Access Compliance Report

Public Rights-of-Way

(Curb Ramps)

Intersection ID: 8521	Main Street: HILDEBRAND_ST	Cross Street: MARIBEL_AV	Location: NE
ADA ID: A90C83A27C3D	Ramp Type: Perp	Initial Pass/Fail: Fail	Overall Compliance: No
			Severity Score: 33.75

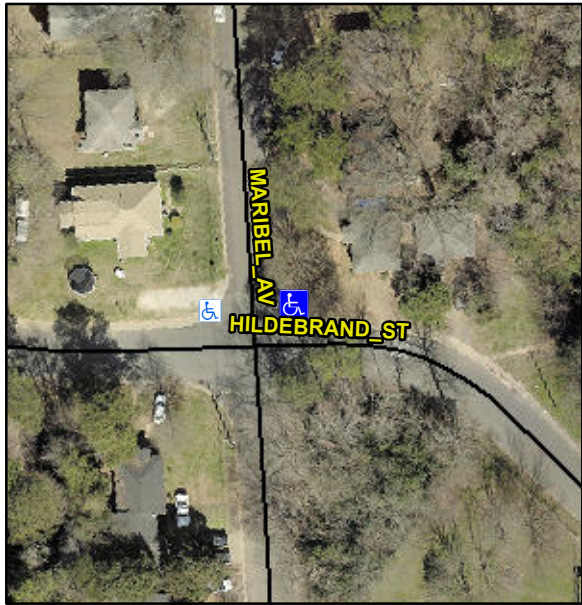
Codes/Mitigation Info/Possible Solution			Field Measurements/Component Compliance									
	Possible Solutions:		Compliance			Description			Data			
	Remove & Replace Entire Ramp.		N/A	Ramp Length (in)		48.0		Yes	Ramp Slope (%)		7.0	
			No	Ramp Width (in)		40.0		No	Ramp XSlope (%)		10.0	
			N/A	Flare Type LT		N/A		N/A	Flare Type RT		N/A	
			N/A	Flare Slope LT (%)		N/A		N/A	Flare Slope RT (%)		N/A	
			N/A	Flare Traversable LT?		N/A		N/A	Flare Traversable RT?		N/A	
			N/A	Landing Length (in)		N/A		N/A	DWS Provided?		N/A	
			N/A	Landing Width (in)		N/A		N/A	DWS Contrast?		N/A	
			N/A	Landing Slope (%)		N/A		N/A	DWS Length (in)		N/A	
			N/A	Landing X Slope (%)		N/A		N/A	DWS Full Width?		N/A	
Surveyor Notes:	N/A		N/A	Landing Curb? (Y/N)		N/A		N/A	DWS Offset (in)		N/A	
			N/A	Shared Landing?		N/A						
			N/A	Gutter Ponding?		N/A		N/A	Gutter Slope (%)		N/A	
			N/A	Gutter Lip Ht (in)		N/A		N/A	Gutter X Slope (%)		N/A

N/A	Painted X Walk1?		No		N/A	Painted X Walk2?		N/A	
				X Walk 1 Direction		To W			X Walk 2 Direction		N/A	
			N/A	X Walk 1 Width (in)		N/A		N/A	X Walk 2 Width (in)		N/A	
				X Walk 1 Slope (%)		4.4			X Walk 2 Slope (%)		N/A	
				X Walk 1 X Slope (%)		4.0			X Walk 2 X Slope (%)		N/A	
			N/A	Ramp inside XWalk1?		N/A		N/A	Ramp inside XWalk2?		N/A	
PROW/ADA:	Not Found, R304.5.1, R304.5.3			Road Slope (%)		N/A		N/A	Clear Space?		N/A	
				Road X Slope (%)		N/A		N/A	Clear Space to XWalk (in)		N/A	
			N/A	Any Obstructions?		N/A		N/A	Storm Grate/Utility Hazard?		N/A	
				Obstruction Type					Storm Grate/Utility Type			
								N/A			N/A	
								Yes	Surface Condition? (G/P)		Good	
Total Cost:			\$	1850.00
